CITY OF ST. PETERSBURG, FLORIDA
PLANNING AND DEVELOPMENT SERVICES DEPARTMENT
URBAN PLANNING AND HISTORIC PRESERVATION DIVISION

STAFF REPORT

Community Planning and Preservation Commission Certificate of Appropriateness Request

Case No.:	COA 21-90200045; AVT 21-90400004
Request:	Review of a Certificate of Appropriateness for the window replacement and rehabilitation at 217 10 th Ave NE, a contributing property to a local historic district
Legal Description:	BAYVIEW ADD BLK 8, E 20FT OF LOT 8 & W 55FT OF LOT 9
Parcel ID No.:	18-31-17-05274-008-0090
Date of Construction:	1920
Local Landmark:	North Shore Section – 200 Block of 10 th Avenue Northeast Local Historic District (17-90300004)
Owners:	Michael Hussey Mary Ellen Hussey
Applicant:	Andrej Klobucar, Contractor, Konstrukt Builders, Inc.

1-1

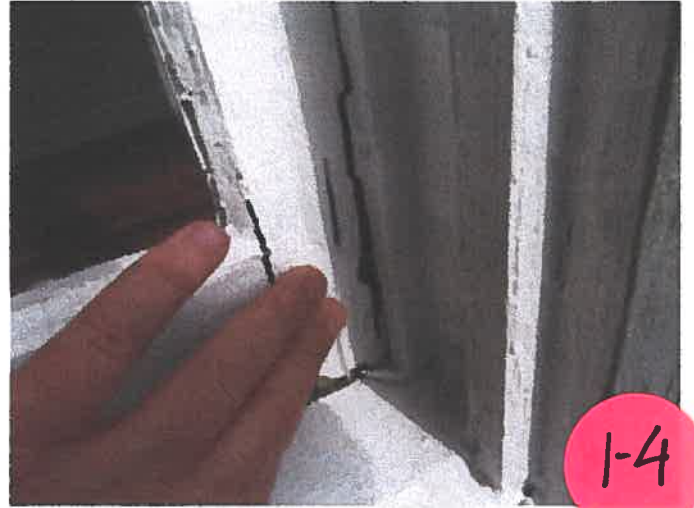
The proposed project will certainly have a positive impact on the district as a whole by re-opening the historic front porch, which is a very significant and character-defining element of the subject property as a contributing property to the local historic district.

The existing porch enclosure is not listed in City permit records but appears to date to the 1970s-1990s by the method of construction. No alterations which have gained historic significance will be affected by the proposed project.

5-1

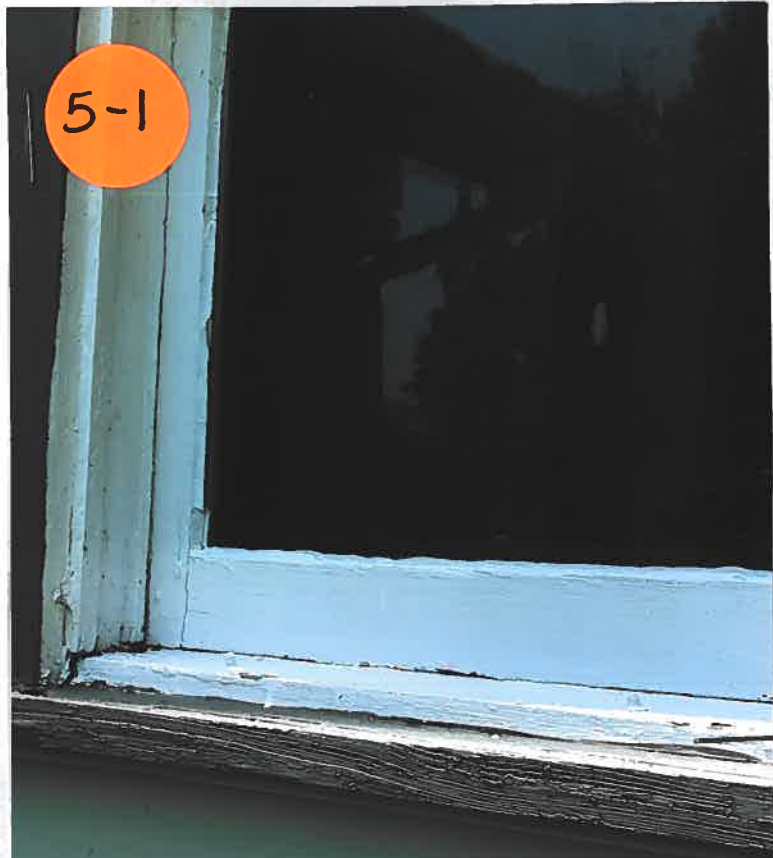
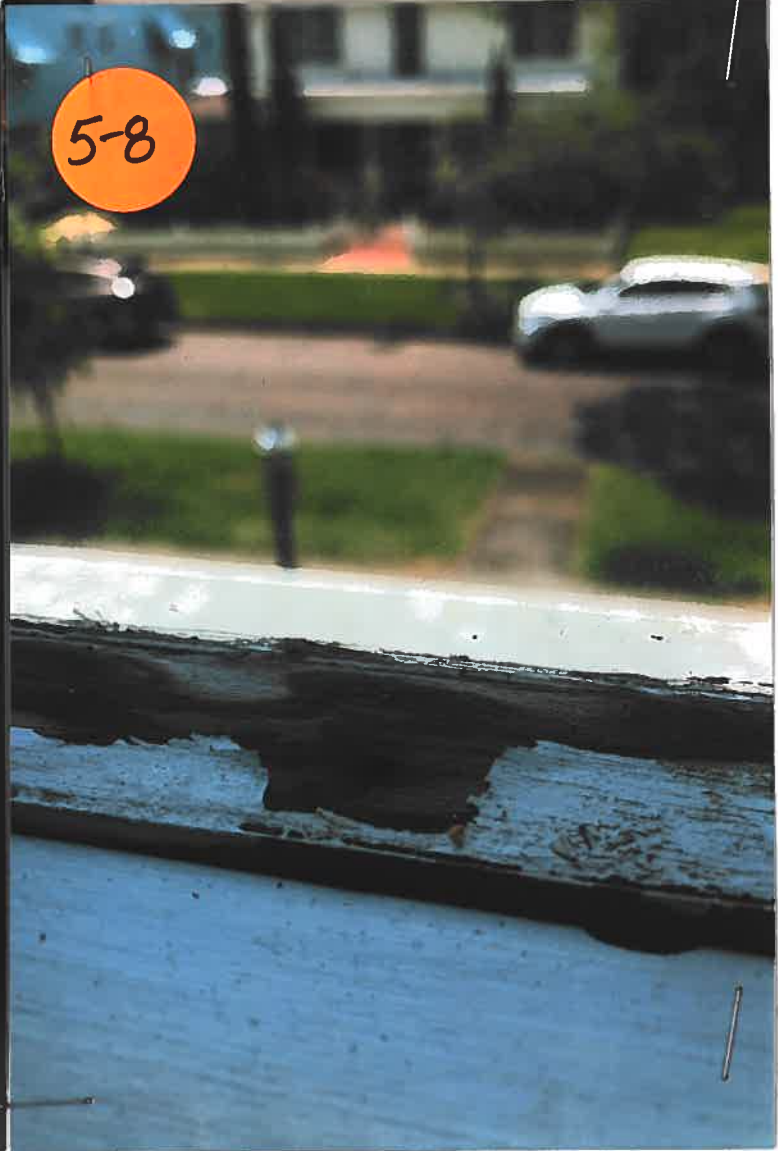
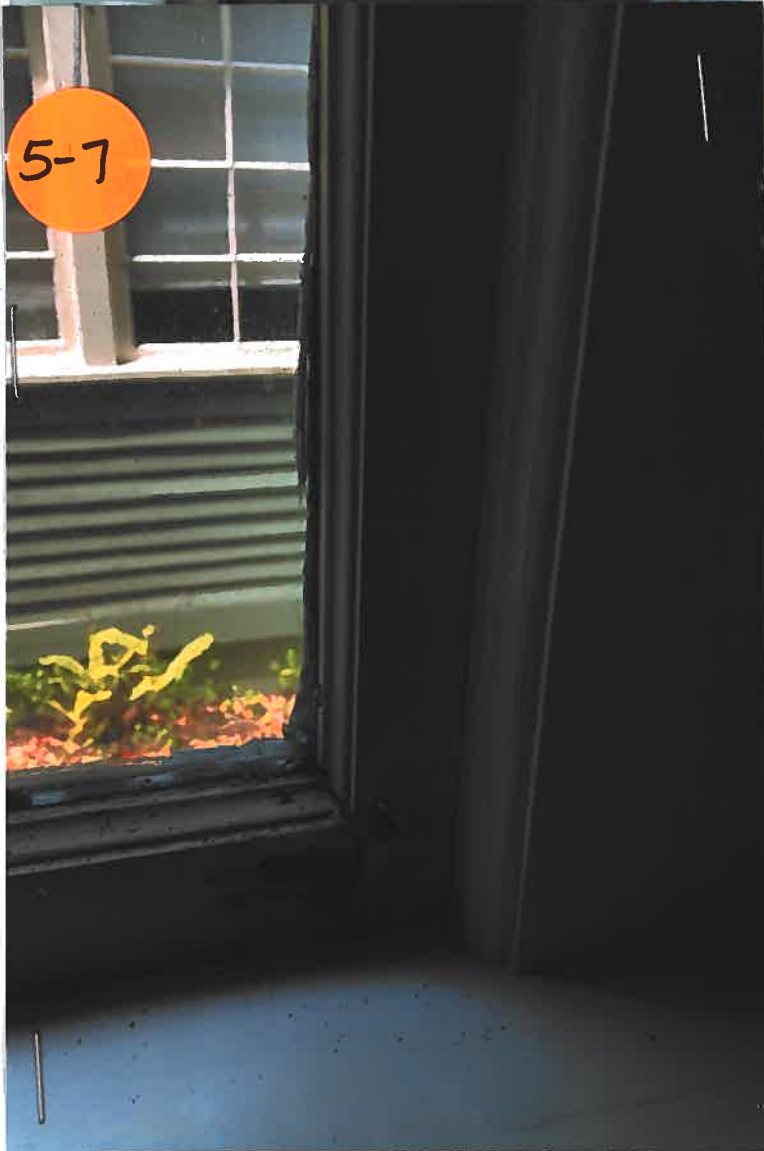
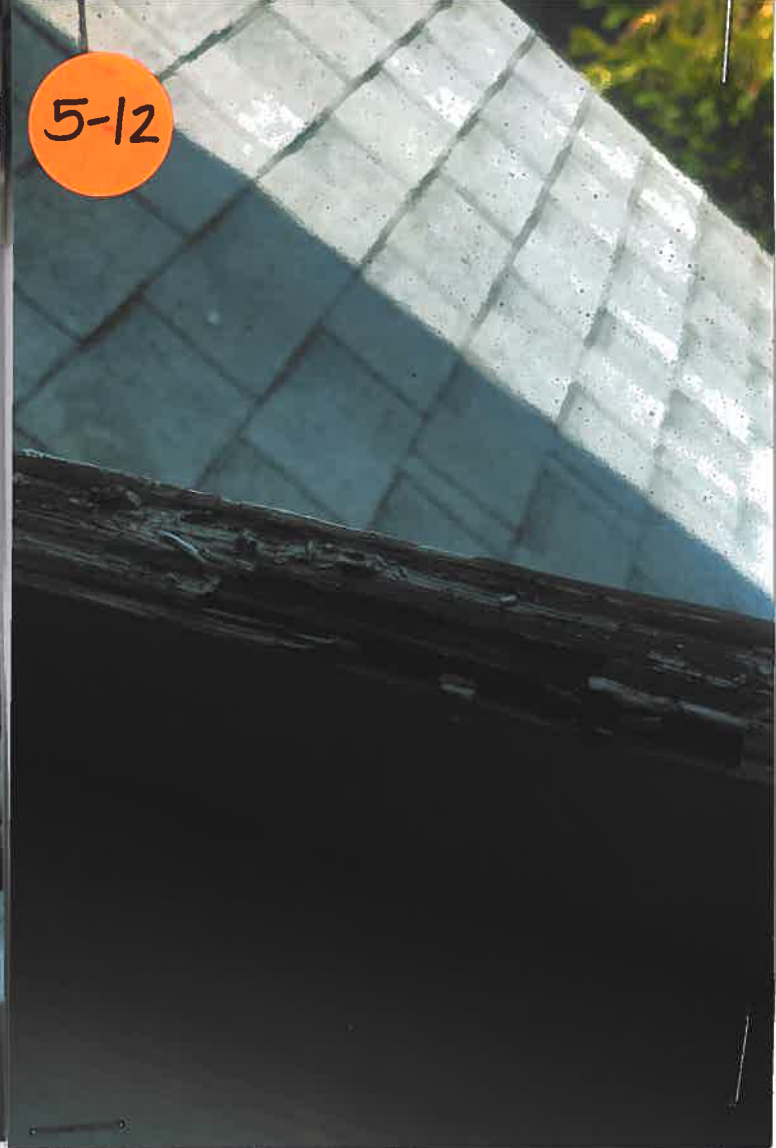
The proposal does include replacing historic windows of the main house. The applicant has stated that they are highly deteriorated and staff has observed areas of rot and termite damage on site visits.

- Significant visible water damaged and many non-operational older windows
- Windows provide no UV protection
- Windows do not have a hurricane impact designation
- Windows have significant rot and termite damage

1. Windows will be installed to be setback within the wall plane and feature a reveal of at approximately two to three inches to provide consistency with the historic windows at subject property.
2. Proposed windows will replicate traditional design and configuration, including four and five-over-one sash windows throughout majority of primary residence as well as seven-over-one irregular sash windows at the façade in the reopened front porch.
3. Historic window trim will be reinstalled or closely replicated.
4. All other necessary permits shall be obtained. Any additional work shall be presented to staff for determination of the necessity of additional COA approval.
5. These approvals will be valid for 24 months from the date of this hearing, June 8, 2023.
